UCH COMPRESSION PROJECT

Design Engineering, Procurement (Supply), Construction, Installation/Erection, Pre-Commissioning, Commissioning & Start-up (including performance testing and Reliability Guarantee Test) of Compression System at UCH Compression Project
Tender Enquiry No. PROC-FC/CB/PROJ/UCH(COM)-4462/2019

PRE-BID CLARIFICATION-11

TITLE: **TYPICAL PLOT PLAN**
WELL HEADS NOS. 01B, 6B, 7, 8, 9, 19, 27 & 32
 COMPUTER CODE: 0221-PC-2201-A
 SHEET SIZE: A3
 SCALE: 1:350
 REVISIONS: —
 Dwg. No. —

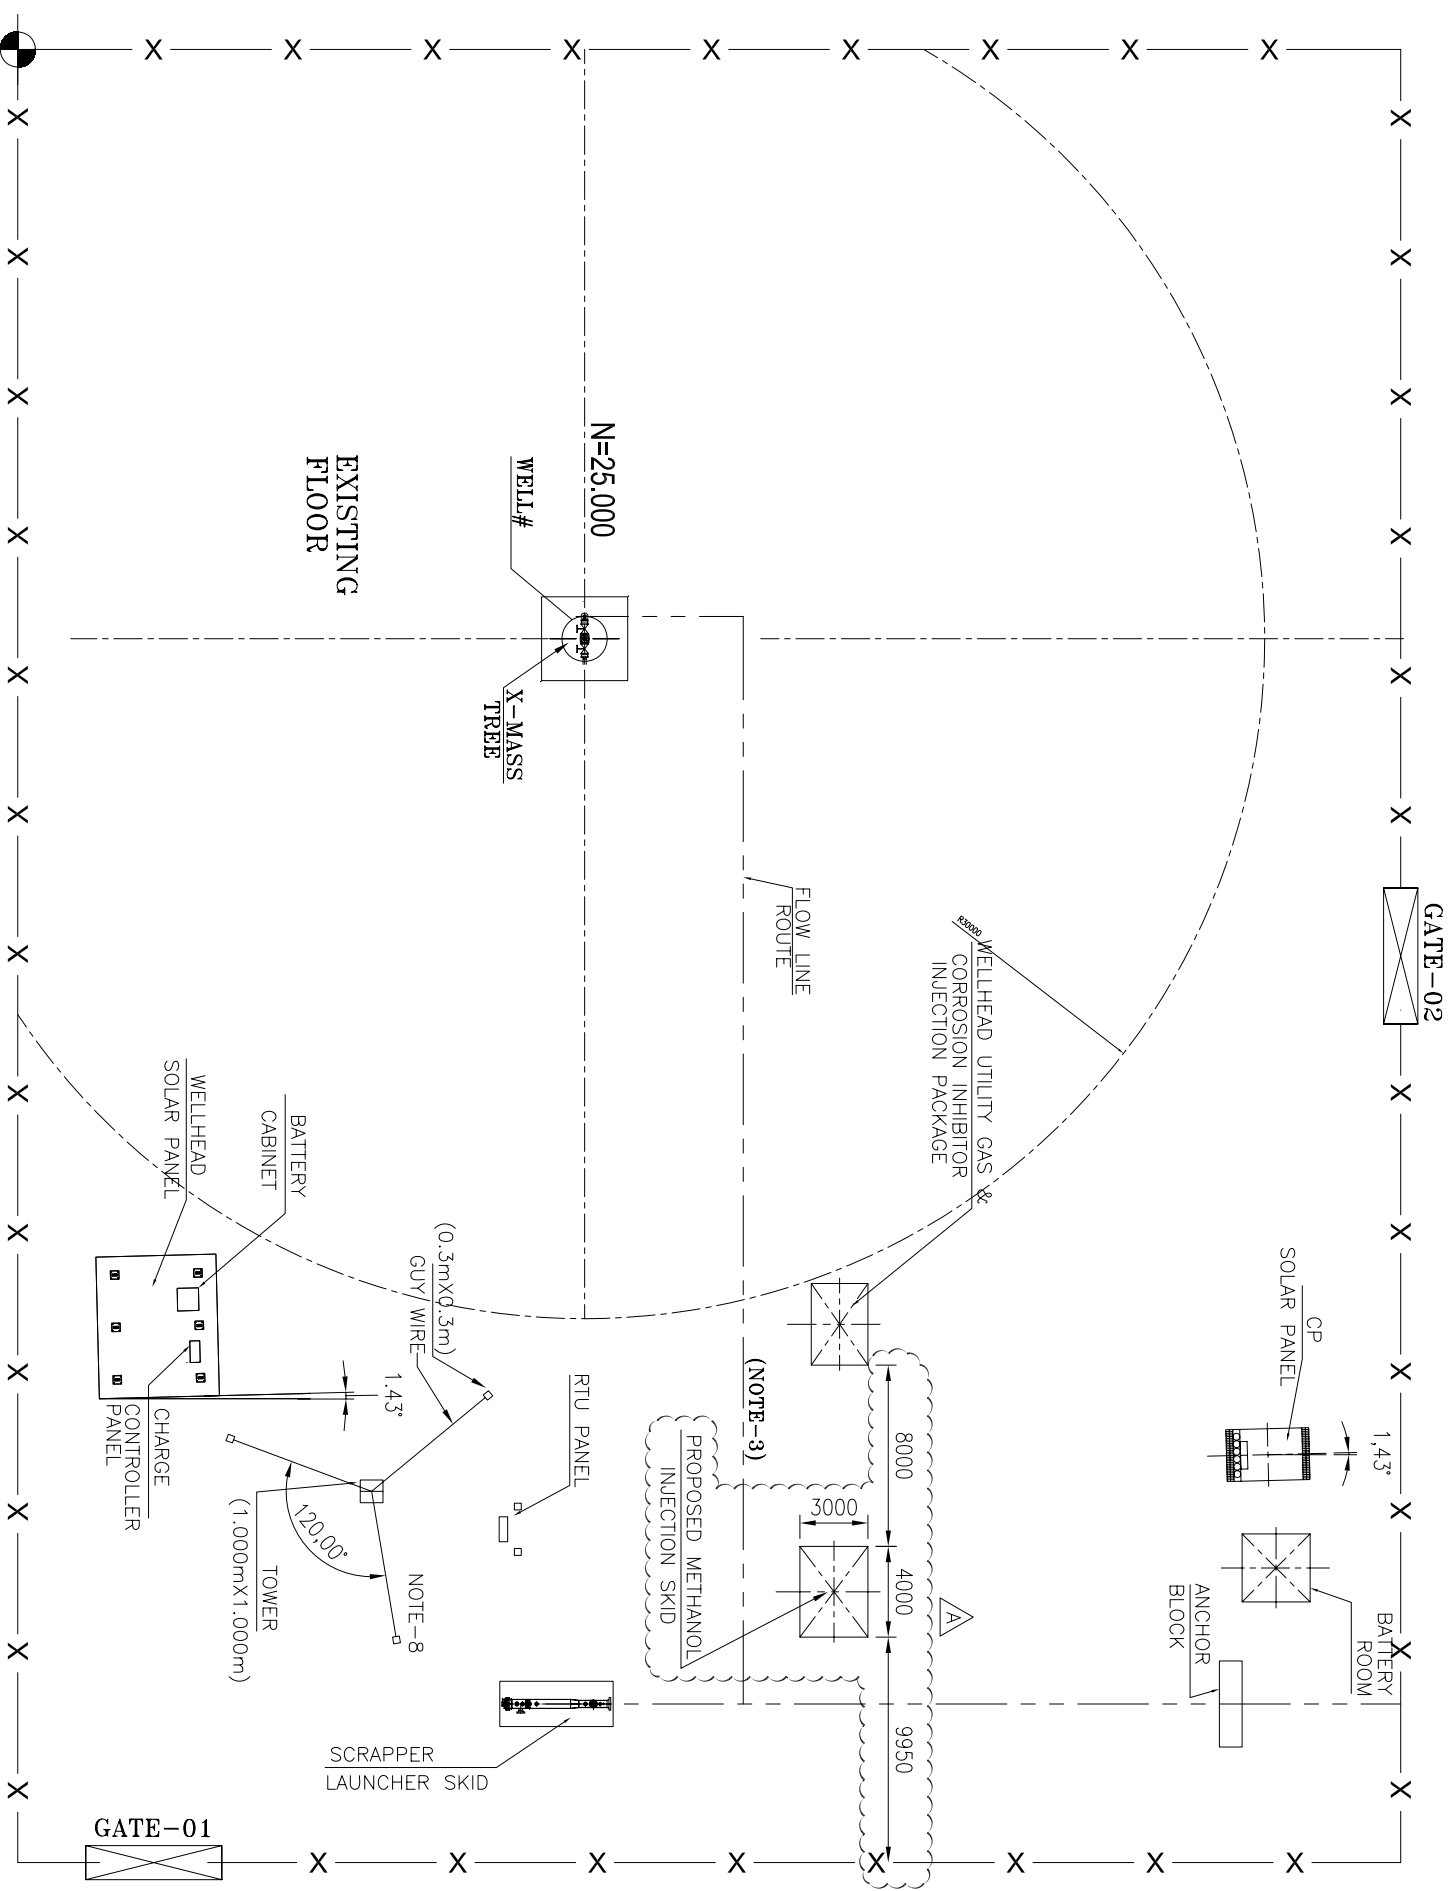
83	UCH-II, Overall Plot Plan	4985-PC-2201	Please provide all relevant drawing information of diesel tank (800- TK1010) and diesel pump (800- P101A/B) to be removed.	P&ID has been provided for reference. Further, tentative location is also marked on plot plan. Bidder to evaluate its quantum of work on the basis of P&ID and plot plan. Please note that the relocation of diesel tank, pumps, piping and associated system, complete in all respect shall be the responsibility of EPCC as mentioned in tender documents.
84	SEC - III _Scope of Work, Section 1.1.11	Final tie in	Bidder understanding that all the final piping tie in works will be executed during the plant shut down. Hence hot tapping is not required for any of these tie ins. COMPANY to confirm.	Referring to Sec.3.6 of referred document, bidder to develop/finalize tie in schedule depicting type of tie-ins as per tender requirements.
85	SEC - III _Scope of Work, Section 2.6	Methanol Injection Skid	As per Bidder understanding, 8 number of new methanol injection skids at Eastern Lobe Wells of both UCH-I & UCH-II plants shall be installed for each wells. Bidder request COMPANY to provide FEED/ Existing documents/ drawings (Plot plan, GA, Layout etc.); for the 8 No. of Wellheads listed in table in P&ID (0221-PB-2200).	Please refer attached Drawing no. 0221-PC-2201-A (Typical Plot Plan For Wellheads).
